### New Wiring Harness

#### Models Affected: All BZT2000's

We have released a New Wiring Harness **2721375** and Relay Mount **2721319.7** for all the BZT2000 units.

Dwg.2

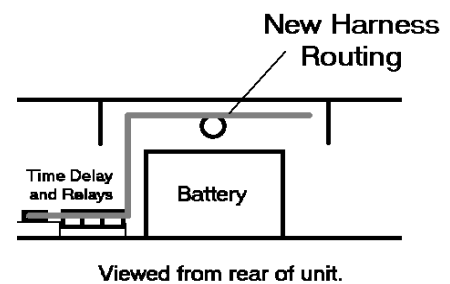
When replacing a 2188213 harness, you must order a **2721375** harness and a **2721319.7** relay mount. The new harness requires that you re-route it across the top of the frame above the battery and then drop it down along the left-side of the battery (Dwg.1). You will have to install the new relay mount 90 degrees clockwise from the previous location and an additional hole must be drilled in the engine deck (Dwg.2). The new relay mount will also allow for the time delay to be mounted on it.
